CITY OF ALBUQUERQUE

Re: Christian Brothers Automotive, 8001 Ventura Plaza
Request for Certificate of Occupancy
Transportation Development Final Inspection
Engineer's Stamp dated 08-01-17 (D20-D010B)
Certification dated 06-11-18

DRAINAGE AND TRANSPORTATION INFORMATION SHEET (REV 6/2018)

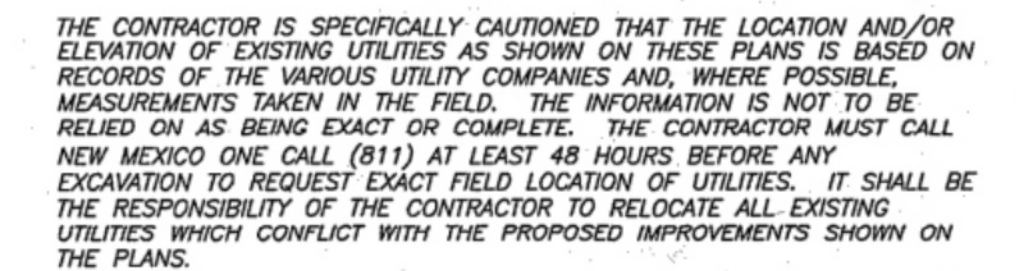
THE FOLLOWING ITEMS NEED TO BE CORRECTED PRIOR TO FINAL C.O.:

- ~~LIGHT POLES NEED TO BE INSTALLED~~
- THE BENCH AND TRASH CAN NEED TO BE INSTALLED
- THE LANDSCAPING NEEDS TO BE COMPLETED PER THE LANDSCAPE PLAN. THE HOTBOX NEEDS TO BE INSTALLED ON BFP.
- THE MOTORCYCLE PARKING SIGN NEEDS TO BE INSTALLED
- THE GATES FOR THE TRASH ENCLOSURE NEED TO BE INSTALLED
